**Ref:** 24399-TN-002

*Site Address:*  
*Jewson*  
*St Andrew's Road*  
*Huddersfield*  
*HD1 6PT*

**Technical Note**  
**Response to Conditions 6 & 7**

**Appendix 1**  
**Proposed Drainage Plan**

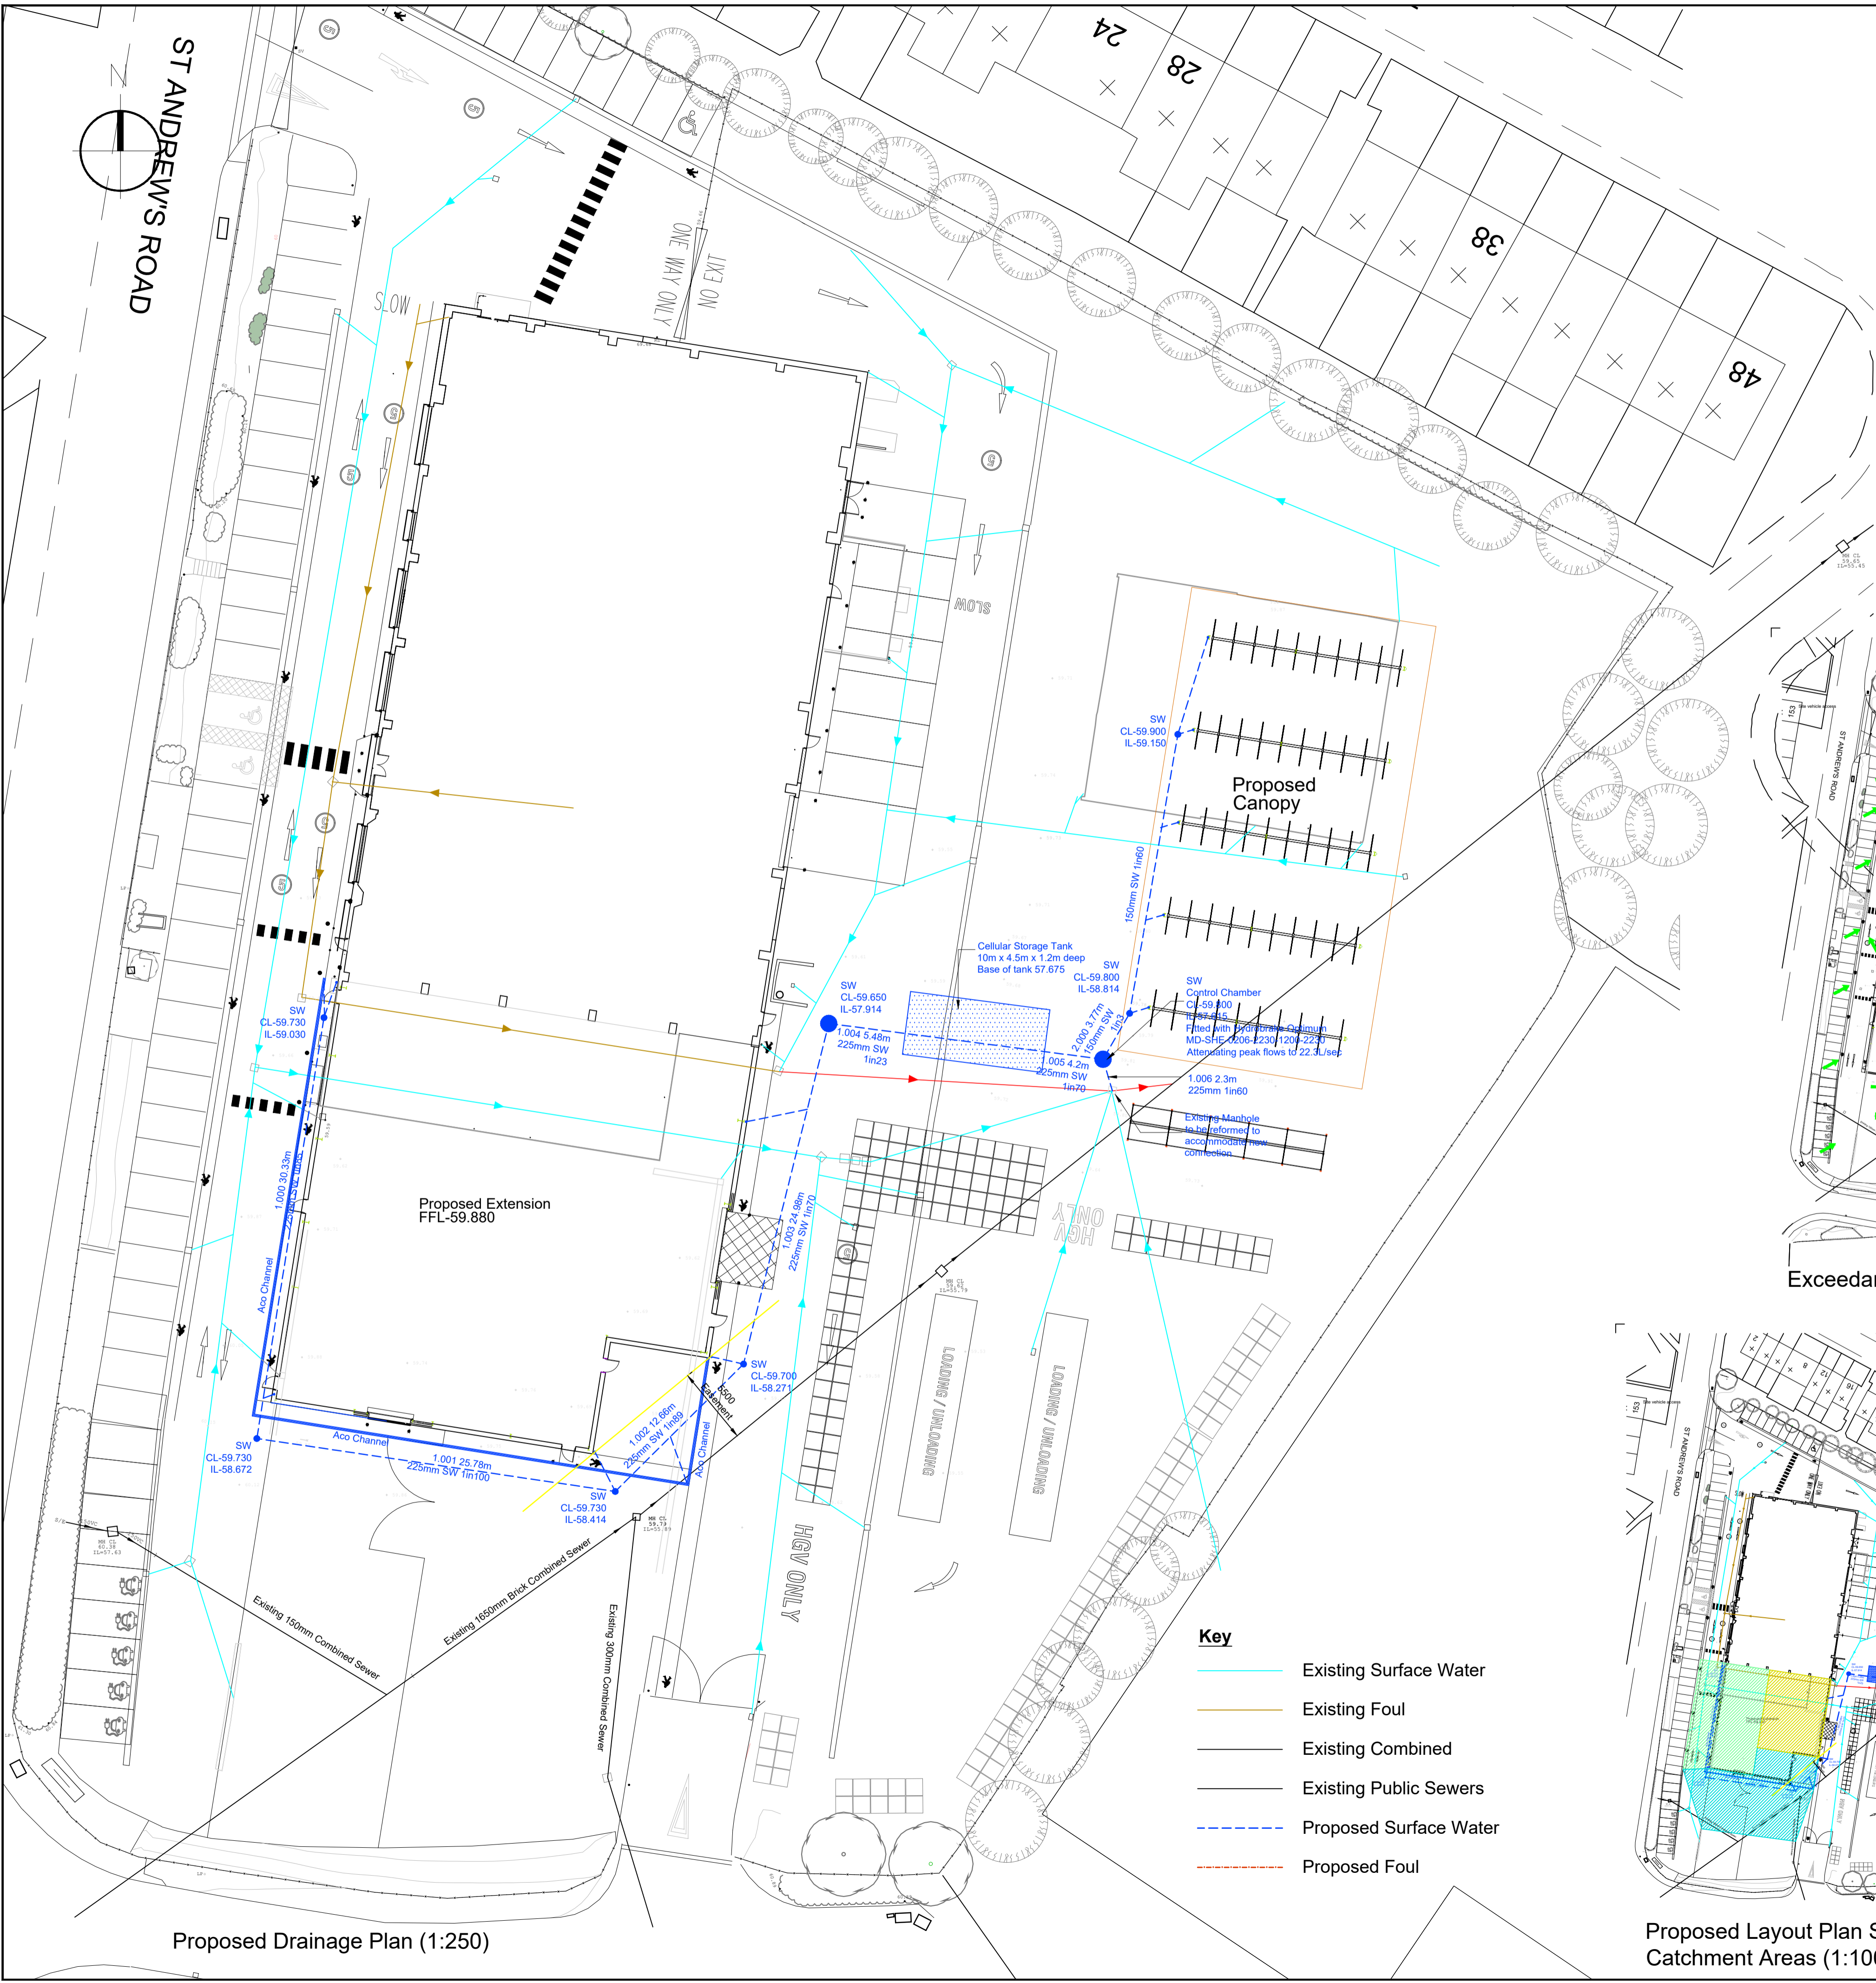
Development shall not commence until a scheme demonstrating surface water from vehicle parking and hard standing areas passing through an oil/petrol interceptor of adequate capacity prior to discharge to the surface water drainage system. Roof drainage should not be passed through any interceptor. The development shall not be brought into use until the approved scheme has been implemented and is fully operational. Thereafter the approved scheme shall be retained.

The proposed surface water drainage, shown in Appendix 1, is picking up roof drainage and a small area of the existing car park. The proposed FFL is set level or higher than existing yard level which means falls will drain as per existing. The ACO channel will pick up less than 500m<sup>2</sup> of car parking area to the west of the proposed extension. Therefore, we do not believe an interceptor is required.
